PLANNING COMMISSION
Regular Meeting
Monday, October 26, 2020
6:00 PM
GoToMeeting Teleconference
Agenda

TO: Planning Commission
FROM: JAC ZADER, ASSISTANT DIRECTOR COMMUNITY DEVELOPMENT
DATE: October 26, 2020
SUBJECT: North Shore Bank. The applicant is seeking conditional use grant and building and site plan approval for a proposed 3,250 sq. ft. bank building with rear drive-through for the property located at 11319 N. Port Washington Road.

LIGHTING PLAN

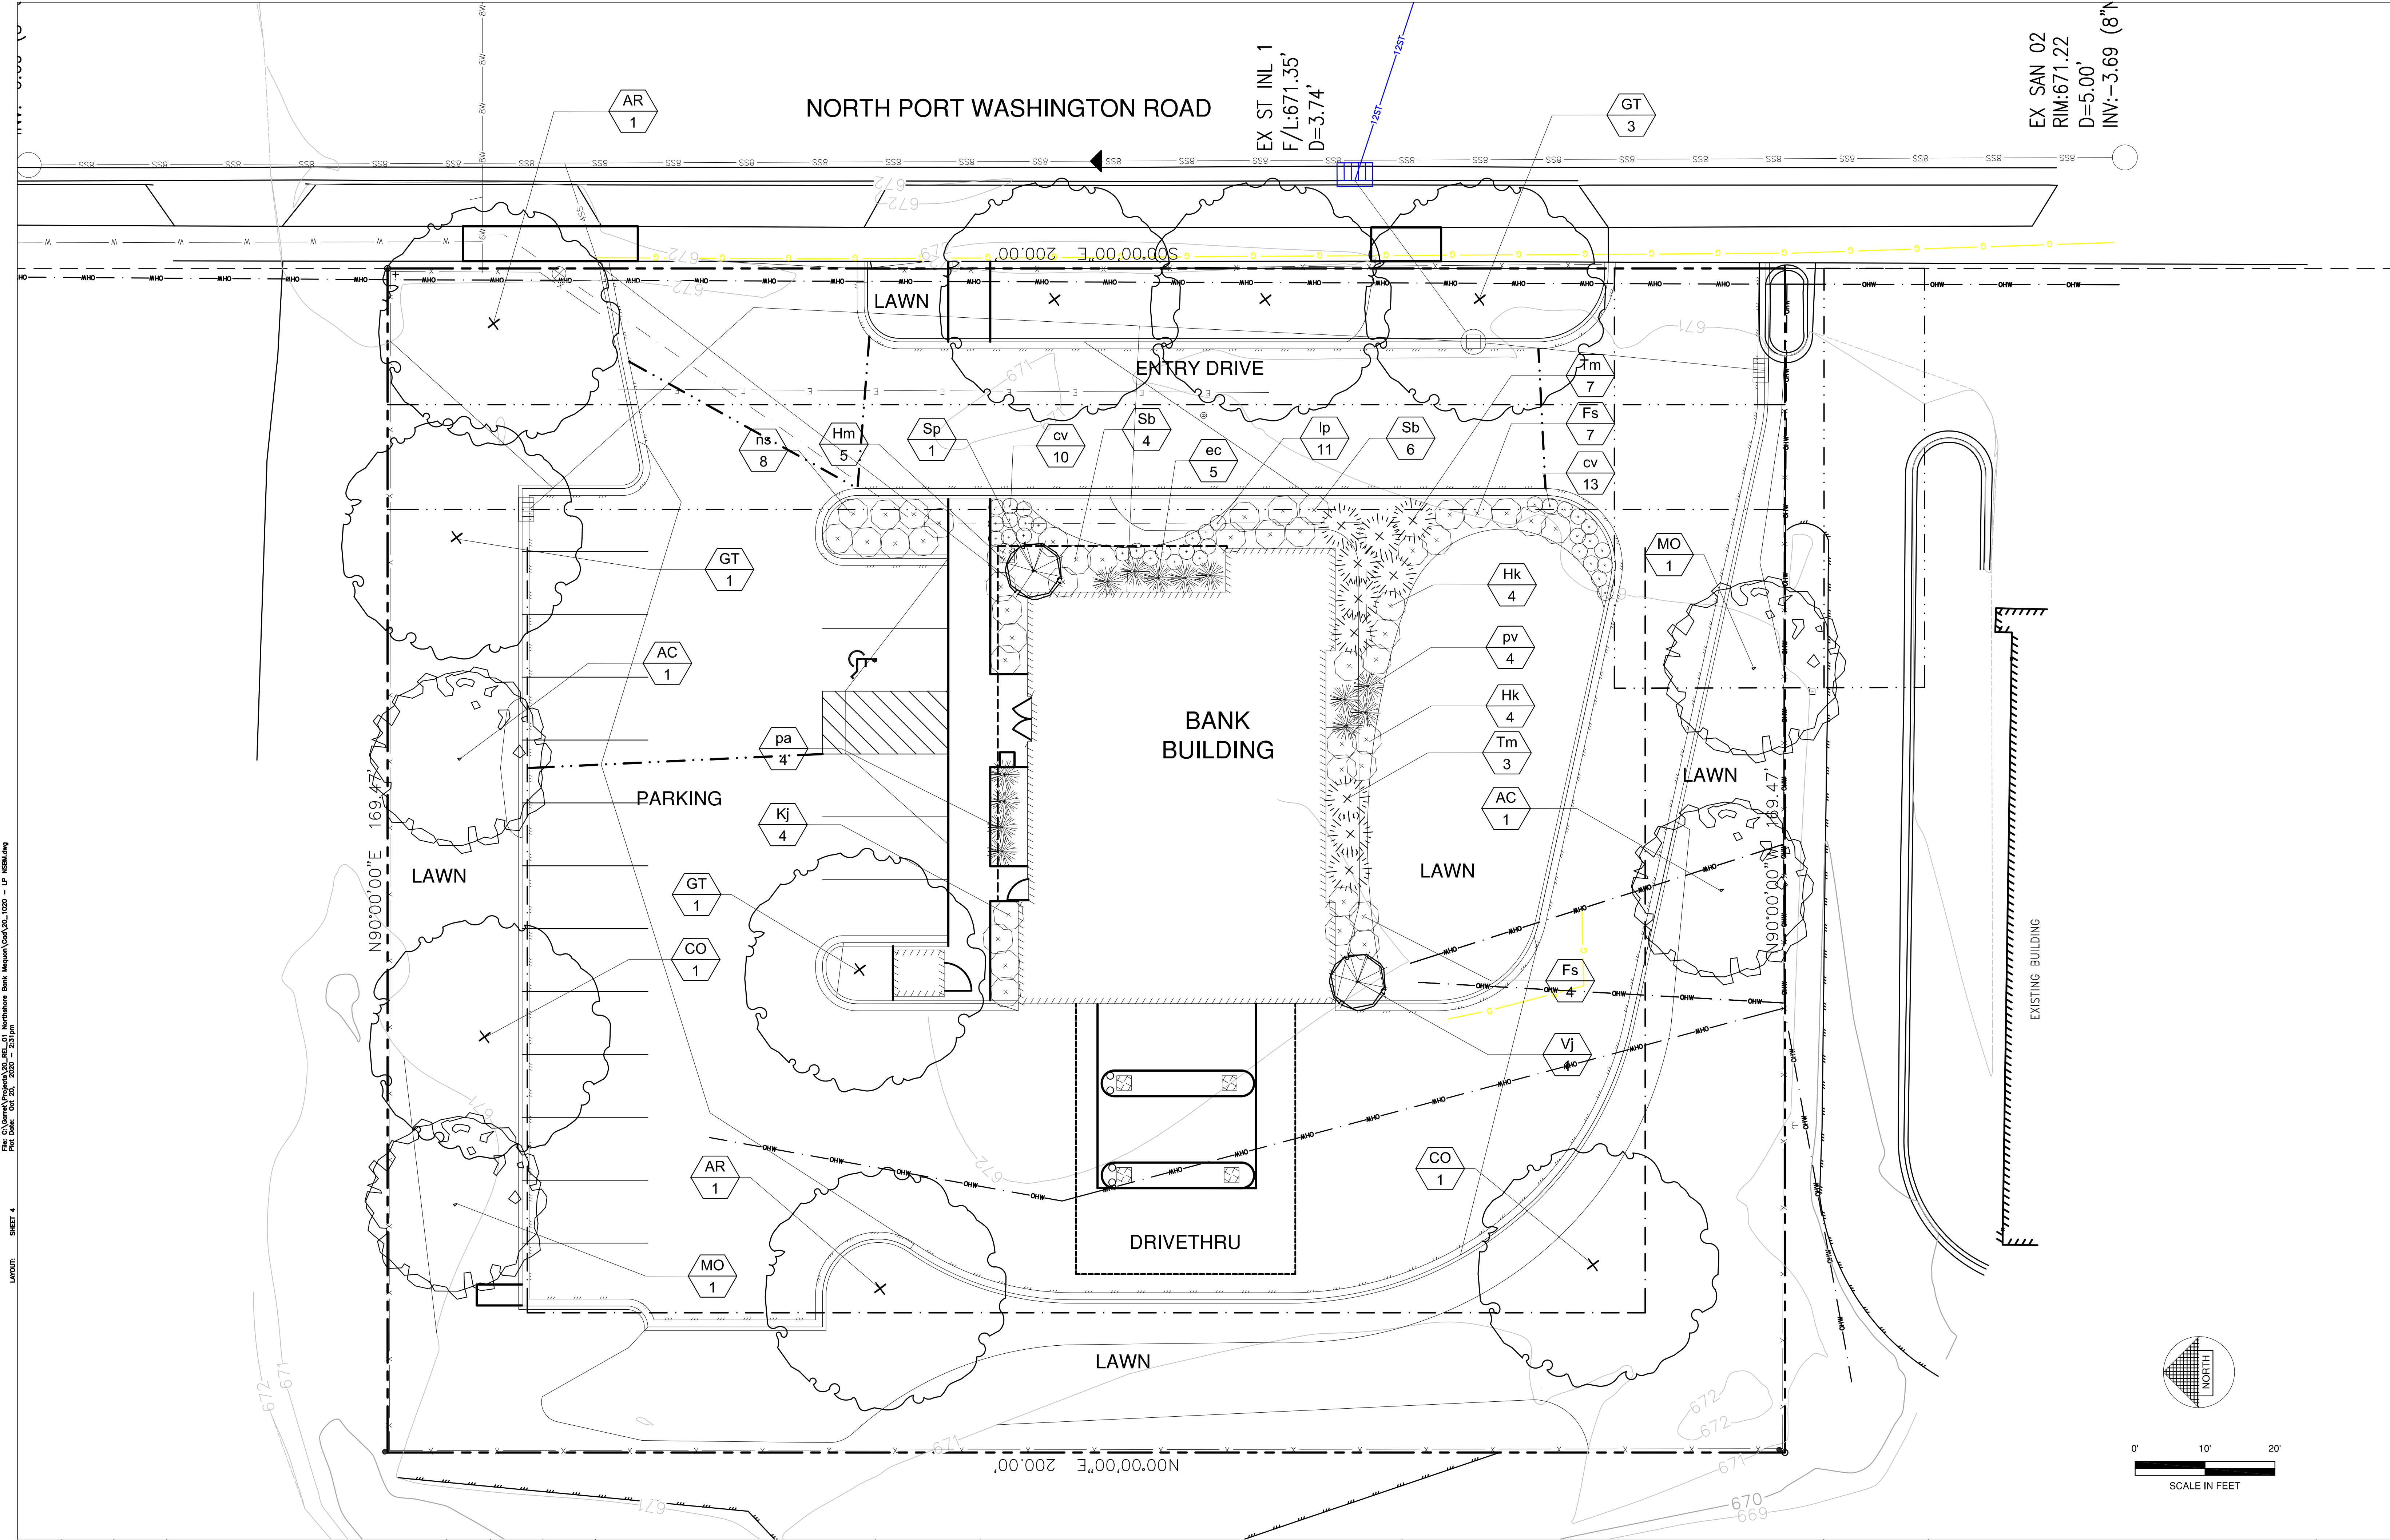
The lighting plan shows parking lot lights, recessed canopy lights and decorative wall sconces. The applicant has provided a dispersion plan for the site. The plan does not address whether the parking lot complies with the average 2.0 foot-candle requirement. The plan also shows that light trespass levels exceed the .05 foot-candle requirement at the rear of the site. Staff conditions the approval on an updated plan to show compliance with both of these issues. The applicant provides cut sheets for the proposed light fixtures. The documents don't show whether the parking lot lights comply with the full cutoff requirements of the lighting code. Staff requires and conditions the approval on documentation that compliance with this requirement is met.

6. An updated lighting plan shall be submitted to show the following:
 - 2-foot candle parking lot average
 - Light trespass does not exceed .5 foot-candle

LANDSCAPE DETAILS

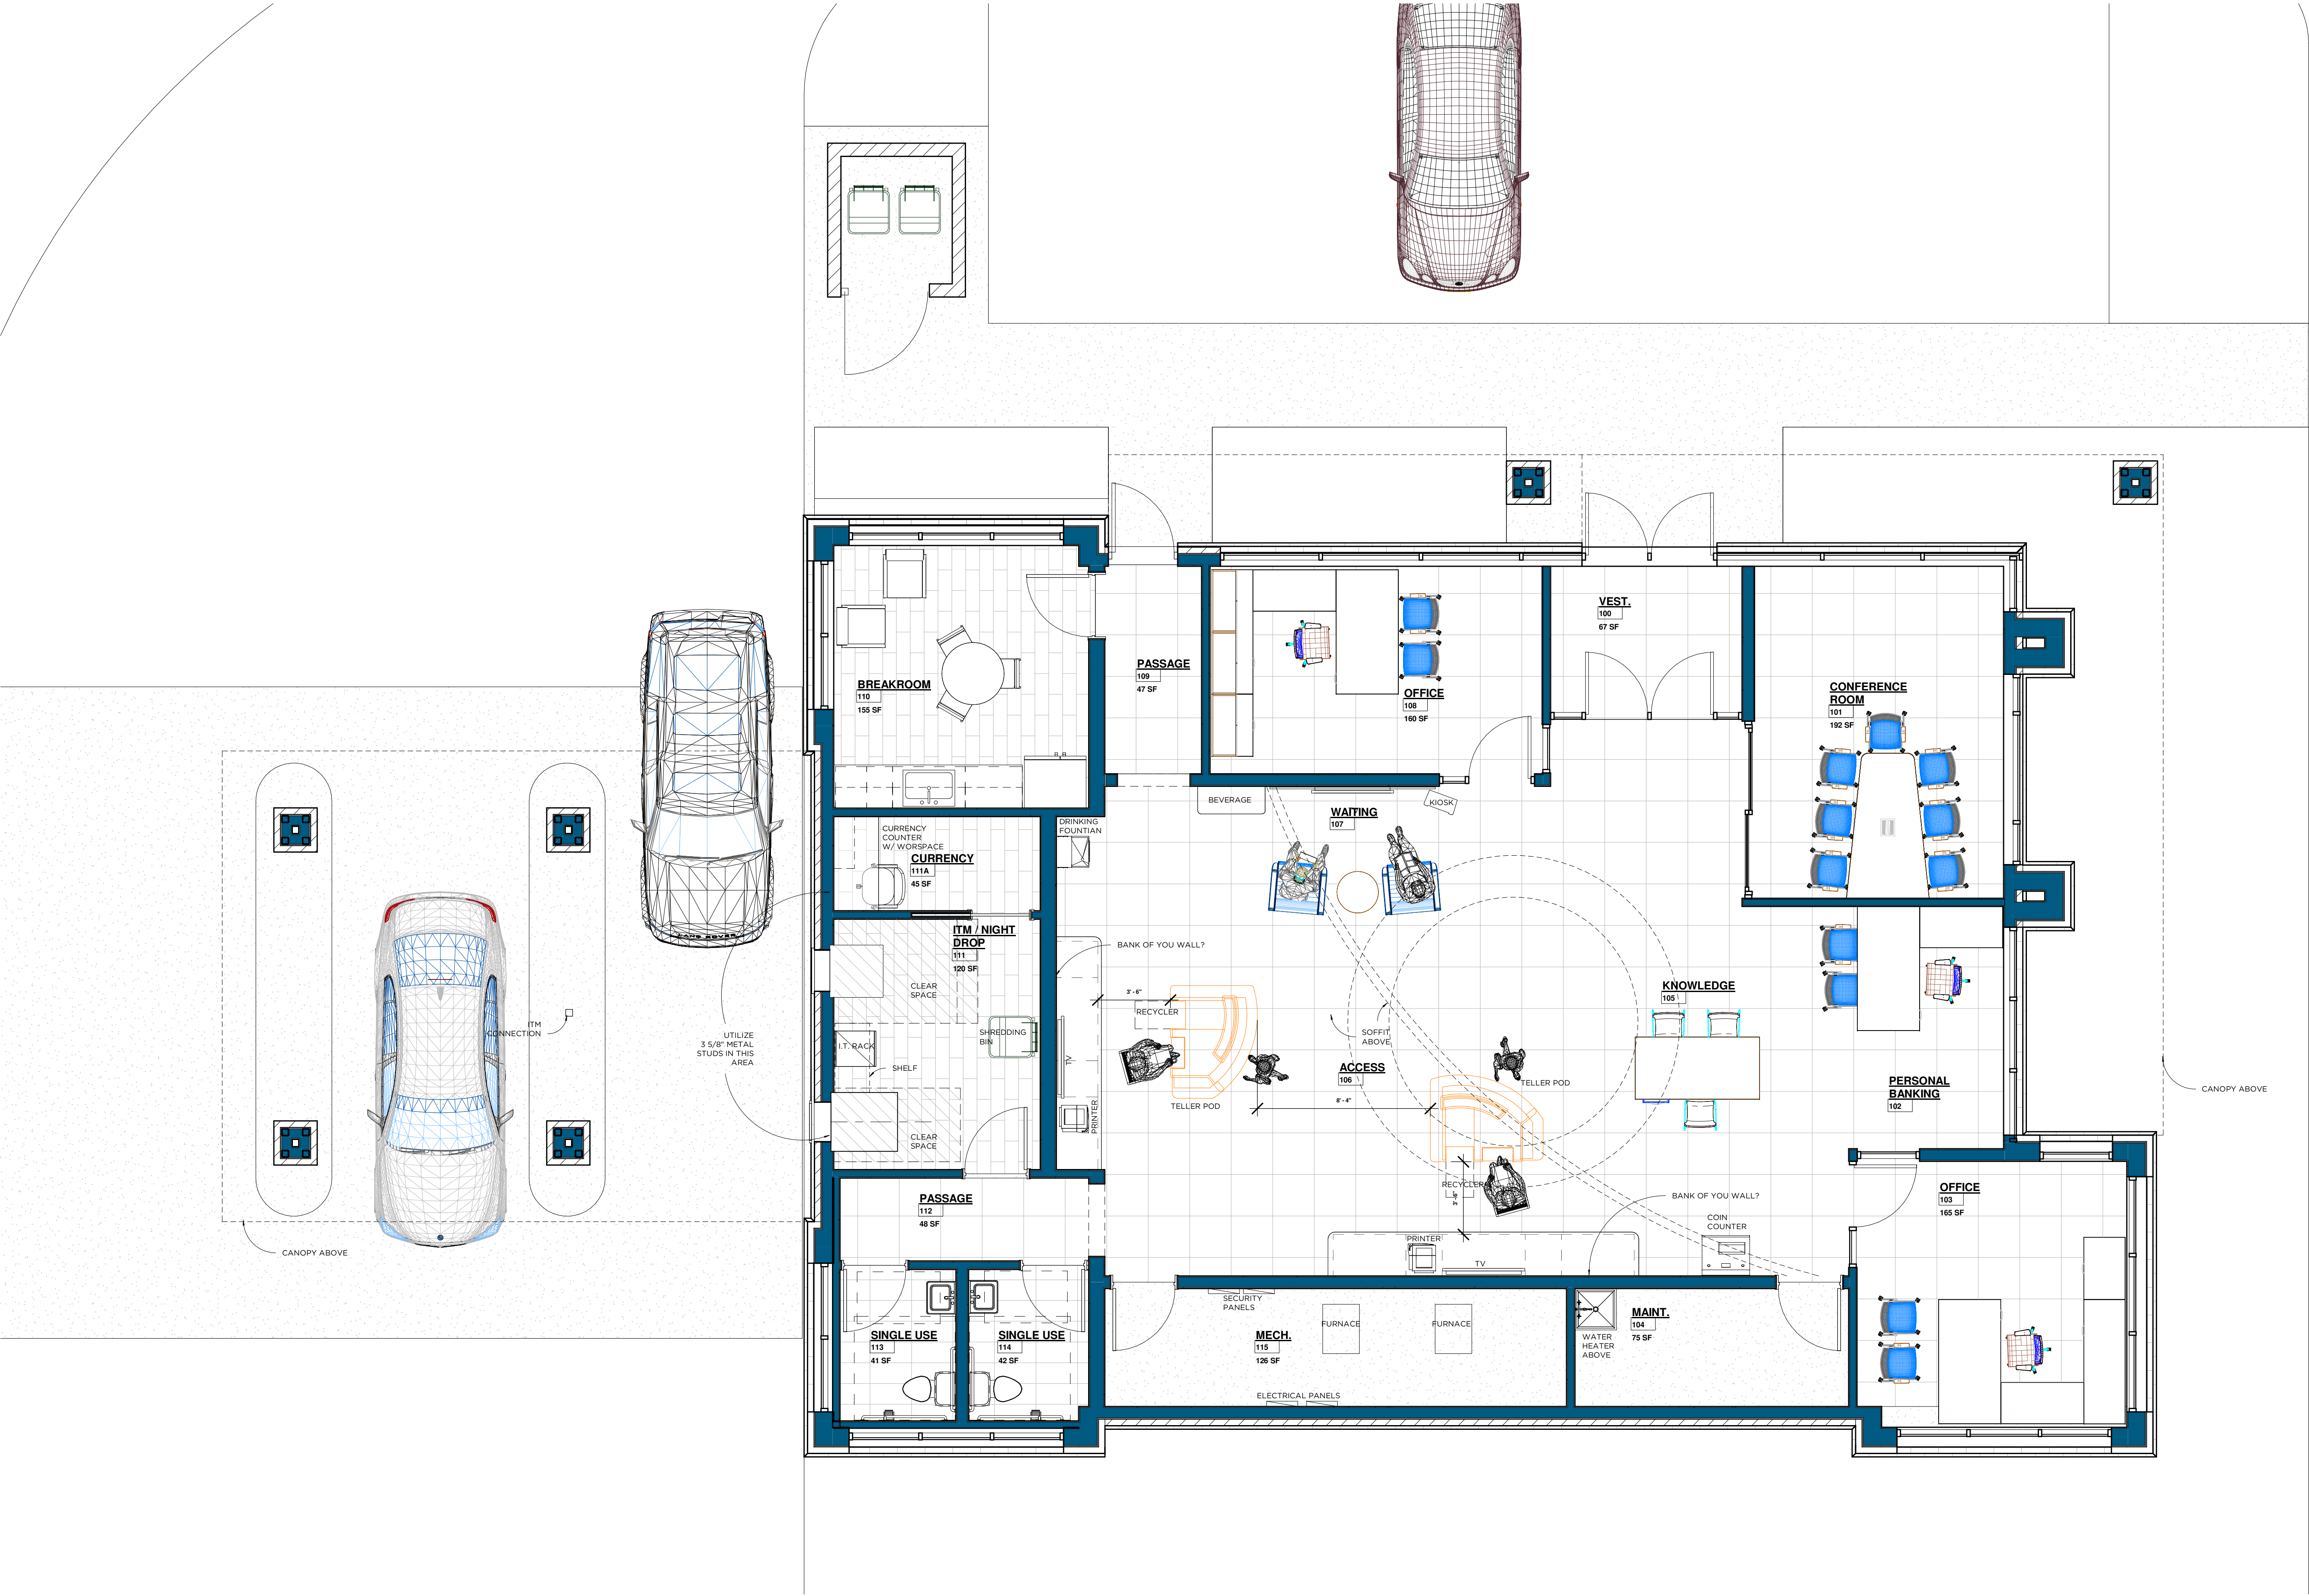
- ❖ This review pertains to Landscape Plan sheets: 14 & 15, both dated 09/2020. Sheet 14 is titled, LANDSCAPE PLAN; plan sheet 15 is titled LANDSCAPE DETAILS.

- The entire plant schedule requires an audit; only 5 of the 19 listed plants have an accurate count.

○ GT_Gleditsia tricanthos “Skyline”, the schedule states 1; graphically, zero is depicted. Amend plan.

○ AC_Amelanchier canadensis (Hasselkus, PhD – UW Arboretum & Dirr, PhD_Arnold Arboretum – lists this as a tall shrub) Amend plan.

○ Taxus tauntonii, the schedule lists 11, the plan only provides 10. Amend plan

○ The following plant symbols have incorrect counts: Fs, Sb, Hm, Hk, Kj, Sp, Vj.
Amend Schedule

- **ROW/Street Frontage Zone:**
- Port Washington Road ROW: Code requires 1 approved street tree per each side of/30 feet of CL length; the Port Washington Rd. ROW planting requirement is not addressed. (The plan FAILS to meet the ROW code tree requirements. Action per P & Z/ Mequon Staff).

- **Street/Interior Drives Zone:**
 - o The Interior Drives: Code requires 1 approved street tree per each 30 feet of drive, on each side of the length. The Interior Drive planting requirement is not addressed in this proposal. The eastern <S/N axis> Ingress/egress drives requires shade trees to address the length of the drives (The plan FAILS to meet the ROW code tree requirements. Action per P & Z/ Mequon Staff)

- Substitute Serviceberry for Honey Locust.
- Provide shrubs or grasses along Port Washington Road between street trees and adjacent to parking lot.

1. The landscaping plan shall be updated to address the following:
 - Substitute Serviceberry for Honey Locust.
 - Provide shrubs or grasses along Port Washington Road between street trees and adjacent to parking lot
